SEPARATE No. D-134

DISCUSSION OF
SOLUTION OF AN HYDRAULIC PROBLEM
BY ANALOG COMPUTER

(Published in June, 1952)

By J. van Veen; W. Douglas Baines, Jr.; T. Blench;
and R. E. Glover, D. J. Hebert, and C. R. Daum

FIG. 5.—BASIC ANALOG CIRCUIT

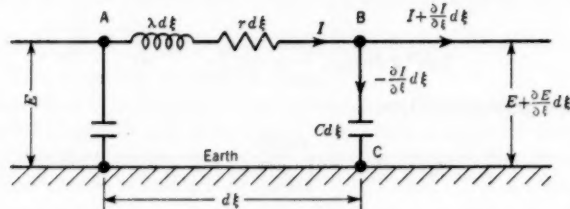
imagined, and the authors are to be commended for their ingenuity in removing the difficulty; however, the derivations of both the hydraulic and the electric equations seem to be incorrect. Fig. 5 is Fig. 2 with the relevant electrical data inserted. In Fig. 5, from A to B—

$$-\frac{\partial E}{\partial \xi} d\xi = r d\xi I + \lambda d\xi \frac{\partial I}{\partial \eta}$$

$$\frac{\partial E}{\partial \xi} + \lambda \frac{\partial I}{\partial \eta} + r I = 0 \dots \dots \dots (28)$$

of which Eq. 28 contradicts Eq. 8.

The dynamical error seems to be in writing Eq. 4 without friction and then applying Eq. 6 separately, as if it were related to the total unsteady nonuniform flow. The writer feels that the method of Mr. van Veen is correct; that is, to write Eq. 4 as

Although it is certainly desirable to obtain a highly accurate representation of the hydraulic conditions, electrical difficulties often make compromises necessary. The development of a tube having adjustable characteristics would greatly facilitate overcoming some of these difficulties. Mr. Blench comments on the neglect of the convective acceleration term. Although his purpose was to emphasize the limitations of the analog, it may be added that electrical devices to represent the convective acceleration term in an analog would be difficult to devise. The writers would prefer to replace the linear resistance term in Eq. 28, as presented by Mr. Blench, with a term of the form I^2/K^2 obtained from the relations expressed by Eq. 10. Such a replacement would lead to an effective procedure for selecting the square-law resistor to represent hydraulic friction in the analog. Suppose the friction term in Eq. 17 of Mr. Baines' discussion had been expressed explicitly in the form Q^2/M^2 obtained by squaring Eq. 18, after replacing the quantity S_0 by S_f . Since, in the writers' application S_0 could be set equal to zero, Mr. Blench's electrical equation and Mr. Baines' hydraulic equation would become analogous and the constants for the square-law resistor could be selected with the use of the correlation equations. Such a procedure should also answer Mr. Baines' question in connection with Eq. 19 because it is a modified form of Eq. 17 which would then be exactly satisfied. This procedure would lead to the same choice of friction constants as were obtained by the writers. The choice of constants for square-law resistors is more readily understood when the friction term is included in the original equations as suggested by Mr. Baines and Mr. Blench. The limitations expressed in assumption No. 2, as listed by Mr. Baines, may be present when lumped electrical components are used to represent a channel, as in the Delta analog. This limitation can be removed by using several electrical components to represent a channel. As many changes of section can then be represented as there are components in the circuit.
